御中		Issue No. / 発行№ : PC-0030405			
		Issue date / 発行日 : 2023/2/27			
工程変更連絡書 Process Change Notice		ヒロセ電機株式会社 郡山工場 品質管理課 Koriyama Factory, Quality control section, Hirose Electric Co., Ltd.			
		承認 (Approval)	査閲 (Review)		
		塚本 Tsukamoto	稲垣 Inagaki		
		作成 (Created by) 野内 Nouchi			
貴社益々ご清栄のこととお喜び申し上げます。日頃は弊社製品のお引き立てを賜り、厚く御礼申し上げます。 早速ですが、貴社への納入製品について、下記の通り工程変更を計画しております。 本書にて工程変更のご案内をさせていただきます。変更計画可否を提出後 2週間以内にご返却を賜りたくお願い致します。 We truly appreciate your significant support always. We are currently planning on the below process change for the products planned to be delivered to your company. Forwarding shares the notification of the process change. Your approval for the change plan within 2 weeks will be appreciated.					
貴社品番/Customer's product number		弊社品番/Product number by Hirose	弊社品名/Product name by Hirose		
		621-0351-5 51(See attachment 1)	A3B-4PA-2DS(51) (representative)		
変更内容 / Content of change	Change 1 区分 Type	Change in packaging method	理由 Reason

Target product list

Details of packaging change

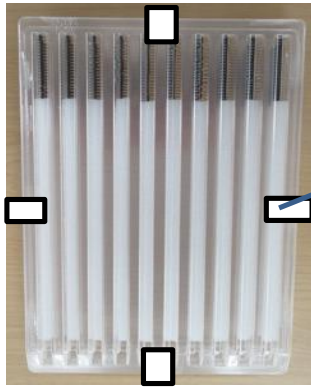
Existing method (before change)

Fasten by using cellophane tape at 8 places

Stack up to 8 trays

New method (after change)

Fasten by using cellophane tape at 4 places

Place cardboard at top and bottom and band them together

Stack up to 8 trays
